# LAND NORTH OF WATFORD ROAD

Review of Potential Noise Impacts

**PROJECT NO. 70042792**

**DATE: MAY 2020**

Figure 1-2 - LNWR Outline Illustrative Layout Option 1

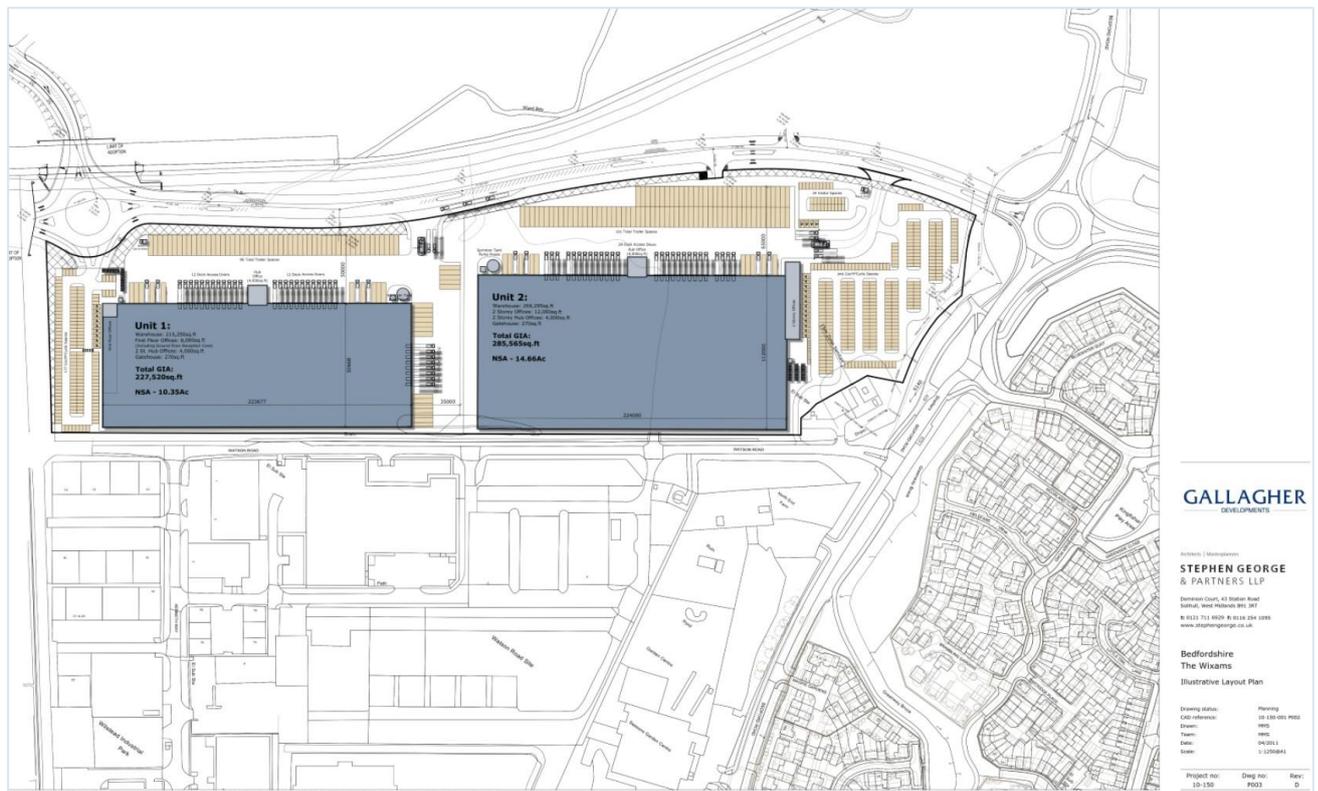
- 4.3.1. The outline application was accompanied by two indicative layouts which are presented in Figures 1-2 and 1-3 above. The application was supported by the A&AC noise report which presented a noise impact assessment based on Layout Option 1 (Figure 1-2).

- 4.3.4. Layout Option 1 positioned the employee carpark between Unit 3 and the closest assessed residential receptors. As a consequence, the Unit 3 Loading bays, service yards and HGV parking that were closest to the receptors were at a distance of around 150m. The gatehouse, where HGVs accessing and egressing the site would have to pull over, was over 100m from the receptors.

- 4.3.5. The A&AC report only predicted noise levels arising from HGV movements and loading/unloading activities and did not consider noise from the use of the carpark. Noise from the HGVs was assessed based on 23 two-way movements during a worst-case hour during the daytime and 5 two-way movements during a worst-case fifteen-minute period during the night time.

**Figure 4-1 - Proposed Layout of the WIP Phase 3 Development**

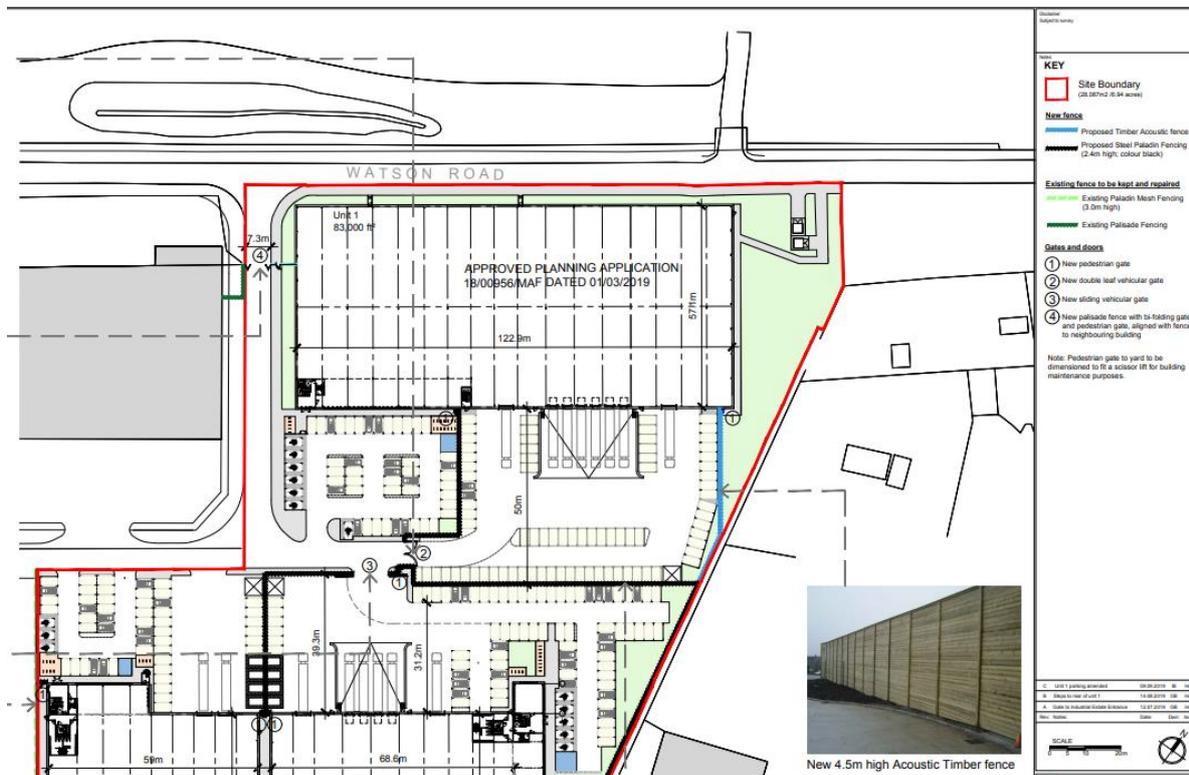
4.2.3. The HL noise report recognised that the proposed layout would result in loading areas, service yards and HGV movements in close proximity to the west boundary of the NEF site. It presented assessments of several sources, based on the principles of BS 4142:2014, which included:

4.2.5. The noise impact from each of these sources was assessed individually (rather than as scenarios where the cumulative impact of several simultaneous activities could be considered) with a 4.5m tall noise barrier in place to protect the future residents of the NEF site as shown in blue in Figure 4-2 above.

4.2.9. No contextual assessment was undertaken, as would be necessary in a BS 4142 compliant assessment.
